General Comments

5.3 Plant Change Process

Figure J-1 – Fire PRA Treatment of Cumulative Risk

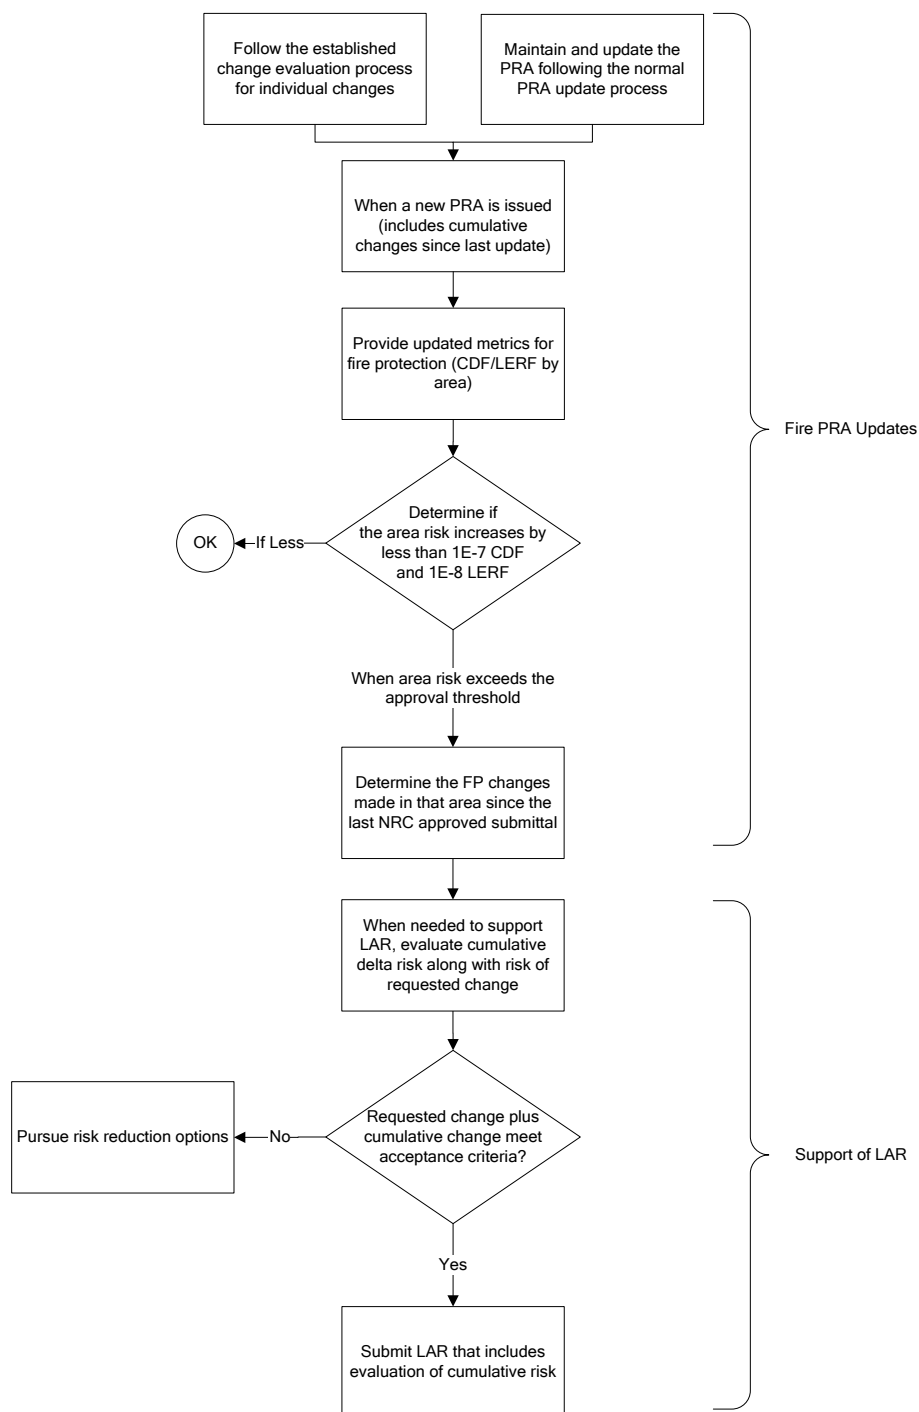
5) The cumulative change in risk in J.6.2 certainly seems to address this complex issue, but the current write-up seems to mix (changes in risk from a change) with (changes in risk following PRA updates). The proposal seems to be:– new changes addressed as they are developed without addressing cumulative, cumulative is addressed during the periodic PRA updates based on changes in fire area risk.

[Yes that was the intent.]

- Follow the established Fire Protection Change Impact Review process for individual changes using the Fire PRA of record. Maintain and up~~grade~~date the Fire PRA following the normal Fire PRA ~~update~~ process. Track the cumulative impact of individual changes undertaken between each Fire PRA- Maintenance and/or Upgrade, and compare to thresholds in RG 1.174 as appropriate.

- When a new Fire PRA is issued (which includes the cumulative impact of changes since last Fire PRA Maintenance and/or Upgrade~~update in addition to the impact of all the plant changes in previous updates~~)

- Provide updated metrics for fire protection (CDF/LERF by area).
 - Determine if the fire area risk increases by less than 1E-07 CDF/yr and 1E-08 LERF/yr. If risk is lower than the threshold, cumulative risk change is satisfactory without the need for additional review. These are conservative change in risk threshold values consistent with the license condition values from Regulatory Guide 1.205, Revision 1.

- When fire area risk exceeds the threshold from above in Step 3, determine the fire protection changes made that impact the fire risk in that NFPA 805 Fire Area since the last NRC approved submittal (e.g., NFPA 805 transition Safety Evaluation or subsequent approval document). Other items such as internal events model changes, component failure rates, human error probability (HEP) values, etc., are not considered fire protection program changes although their change in value could affect calculated risk numbers. -Alternatively, fire protection program changes that affect ignition frequencies, fire growth and propagation, suppression, etc., would be considered fire protection program changes.

- When needed to support a license amendment request, d~~D~~etermine the cumulative delta risk due to those fire protection changes using the Fire PRA model from the previous step~~Step 3~~ above. Use of the current Fire PRA model ensures the most accurate and appropriate measure of risk and change in risk.

- If cumulative impact plus the change being requested is less than the established~~thr~~threshold (RG 1.174) in step 3, no further action is required.

- If cumulative impact plus the additional risk of the change being requested still exceeds the threshold (RG 1.174), determine ~~if~~ viable options for reducing the cumulative risk to within acceptable levels prior to submittal. ~~are available.~~
